**METROPOLITAN GOVERNMENT OF NASHVILLE AND DAVIDSON COUNTY**

**STAFF RECOMMENDATION**  
**1113 Lillian Street**  
**January 21, 2015**

**Application:** Demolition, New construction-infill  
**District:** Lockeland Springs-East End Neighborhood Conservation Zoning Overlay  
**Council District:** 06  
**Map and Parcel Number:** 08313012500  
**Applicant:** John Root, Architect  
**Project Lead:** Sean Alexander, sean.alexander@nashville.gov

**Description of Project:** The applicant is proposing to demolish a non-contributing structure and to construct a new one and one-half story house with attached parking on the interior lot.

# FIRST FLOOR PLAN

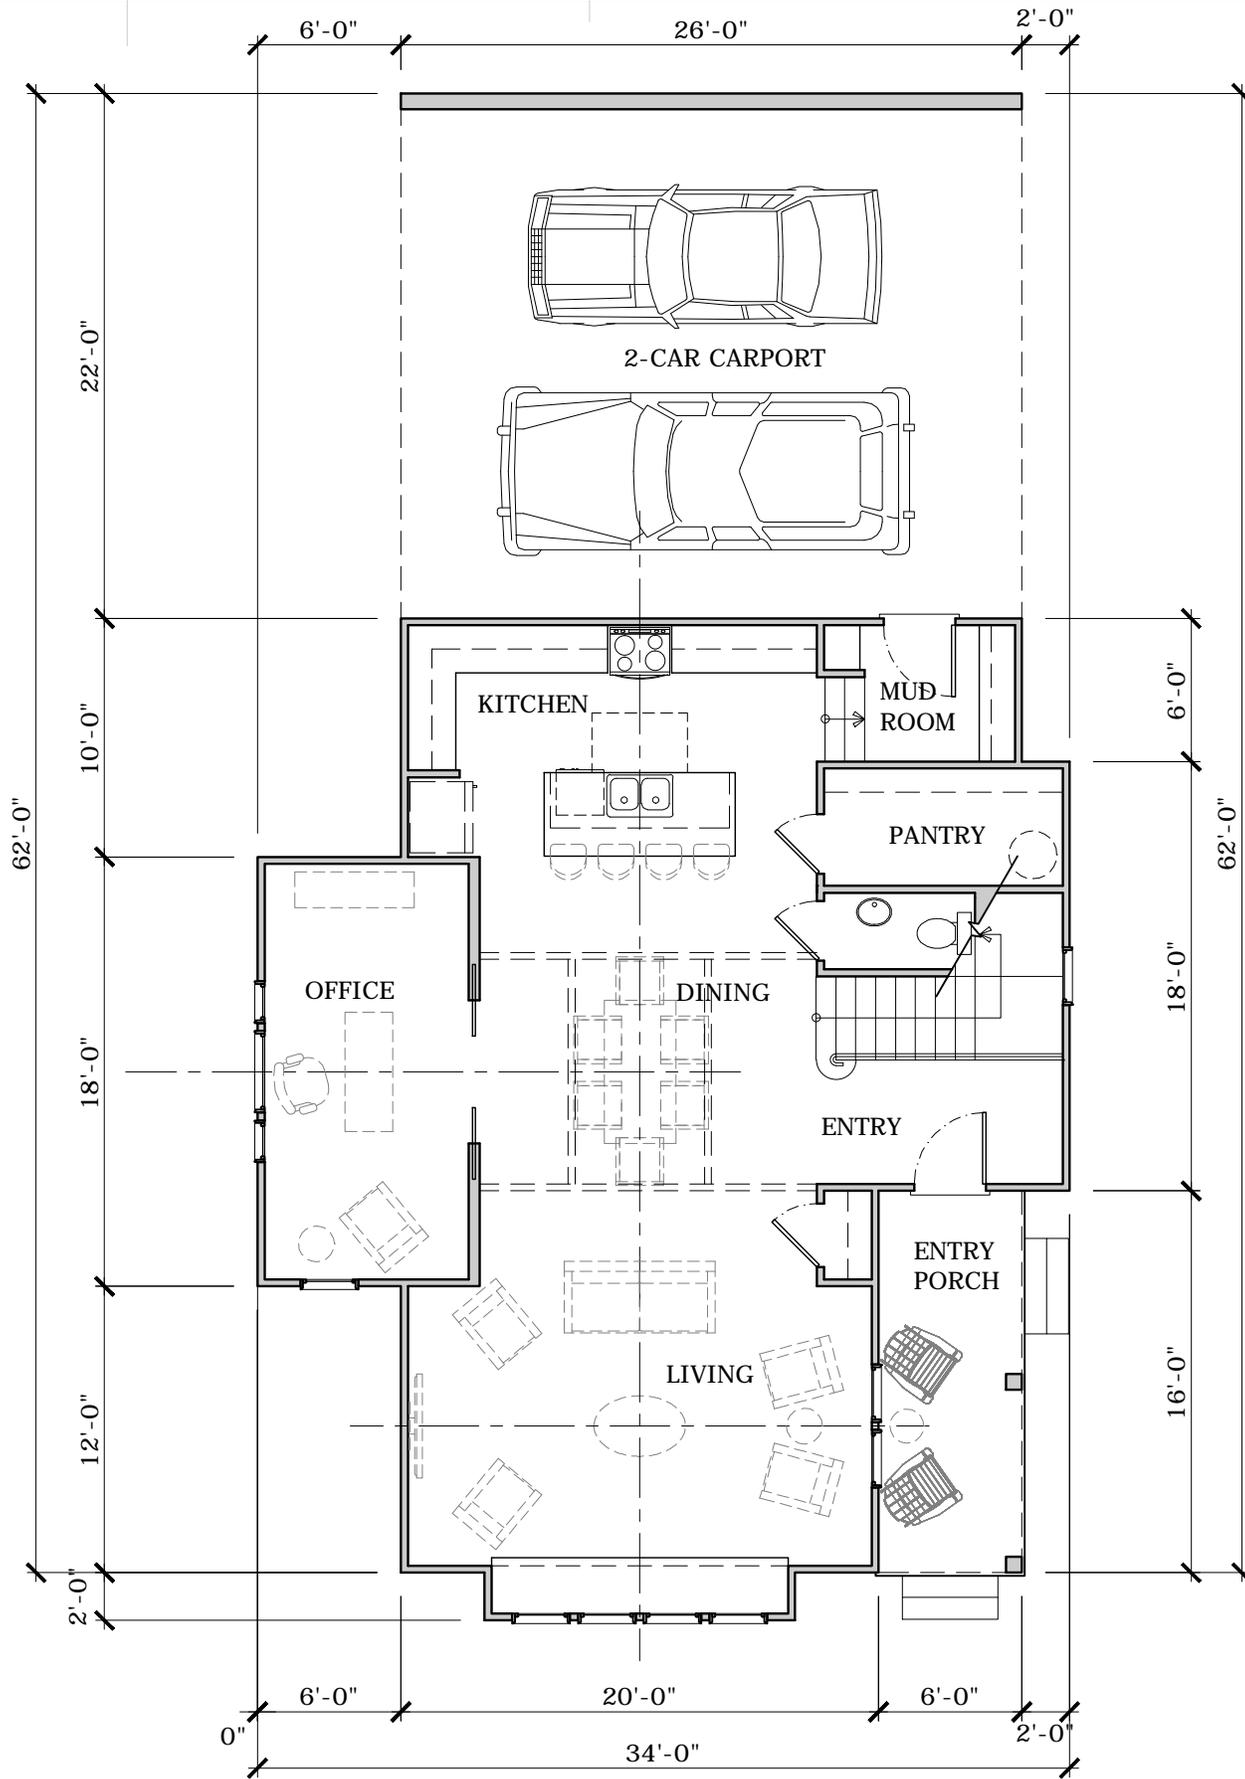
The new structure will be aligned with the front elevation parallel to Lillian Street, with a recessed porch on the right side of the house. This porch will be six feet (6') wide and sixteen feet (16') deep, with the primary entrance at the rear of the porch. Staff finds that such a deep porch obscures and diminishes the entrance to the building in a way that is not in keeping with nearby houses. Typically, historic houses in the area have prominent front porches that engage the front yard and street.

The location of the HVAC and other utilities was not indicated on the drawings, Staff recommends a condition that they be located on the rear façade or on a side façade beyond the midpoint of the house. There will be a concrete driveway on the right side of the house, to which a concrete walkway will connect to the front porch. With a condition that the location of the HVAC is administratively approved, Staff finds that the proposal will meet section II.B.9.

A concrete walkway will lead from the front porch to a driveway running along the right side of the house. As Lillian Street does not have an alley at the rear, this configuration is typical for other similarly situated houses. With a condition that the entrance to the house be made to be more prominent in how it engages the street, Staff finds that the orientation of the building will meet guideline II.B.6.

**STREET ELEVATION**

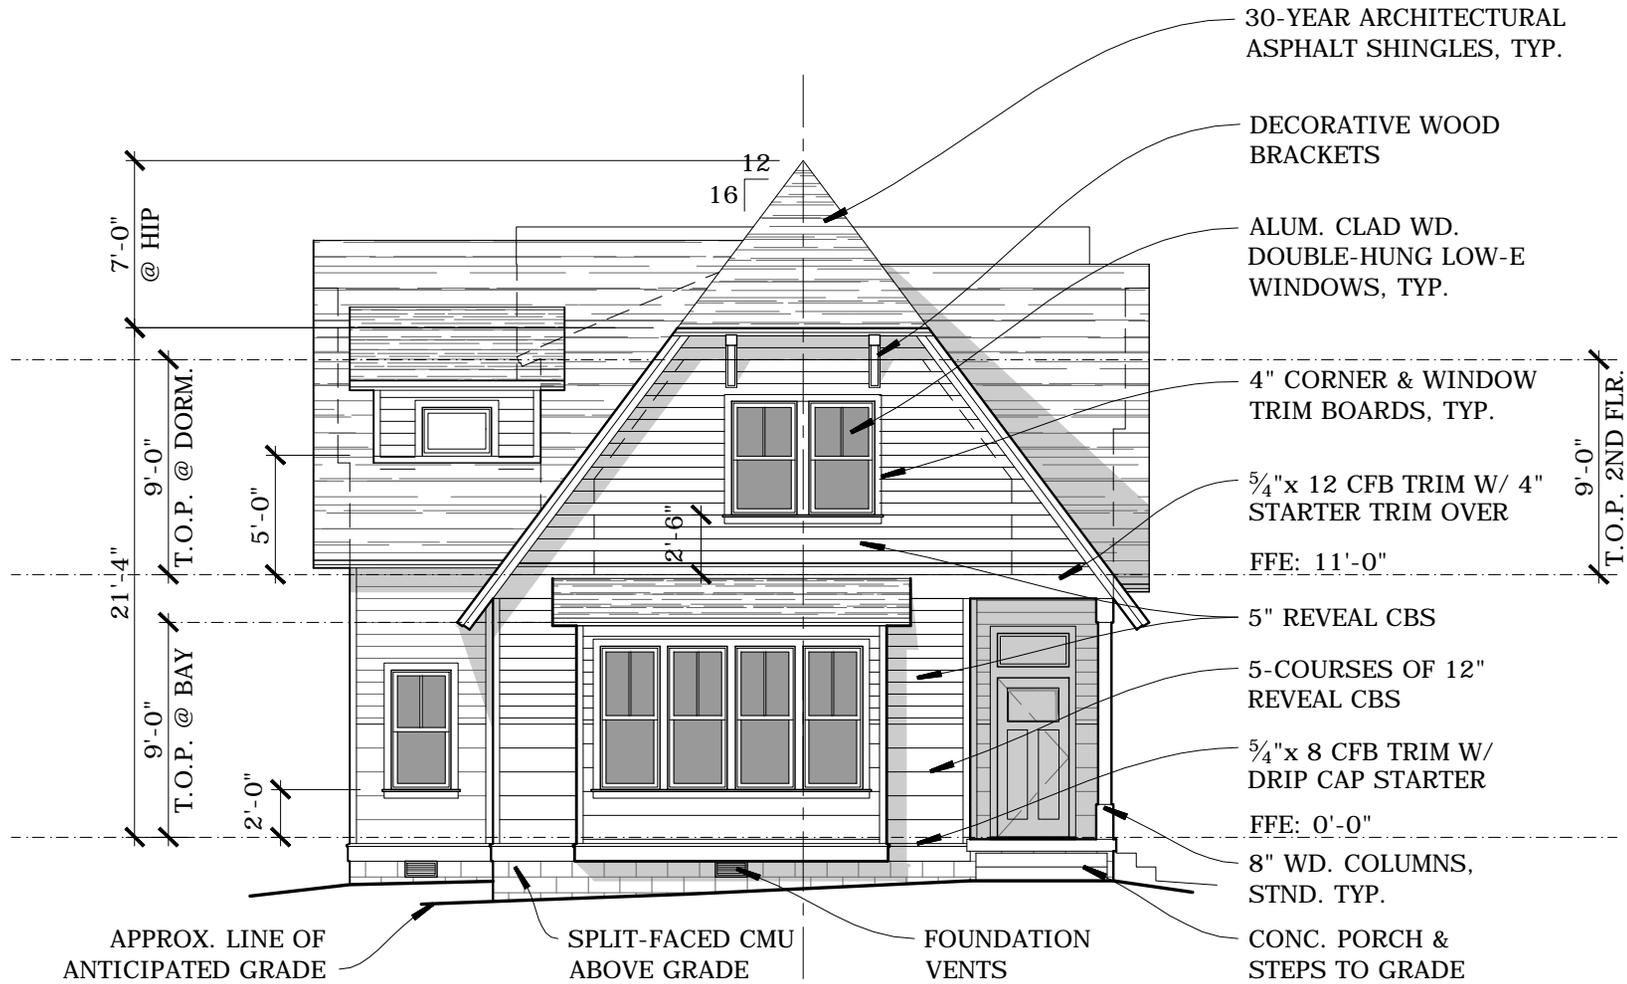
The new house will have a roof height of thirty feet, six inches (30'-6") above grade, including a two foot (2') tall foundation at the front. The primary eave height will be ten feet, six inches (10'-6") from grade, and the front-facing gable of will be clipped with an eave at twenty-three feet, six inches (23'-6") from grade. Although there are no historic houses in the immediate vicinity, recently approved infill on the street ranges from twenty-four feet (24') to thirty-two feet (32') tall.

The roof will be a front-facing gable with a 16:12 pitch, with pairs of side-facing gables on both sides. The front gable will be clipped, which helps to reduce its perceived height. A four-window wide projecting bay on the front elevation will have a 5:12 pitched shed roof. These roofs are compatible with those of surrounding houses, therefore Staff finds that the proposal meets guideline II.B.5.

The windows on the house will be generally twice as tall as they are wide, and the first story windows will be taller than those on the upperstory, as seen historically. The windows have four to six inch (4"-6") mullions between, also as seen historically. There will be no expanse greater than ten feet (10') without an opening on any of the primary elevations. Staff finds that the proposal will meet guideline II.B.7.
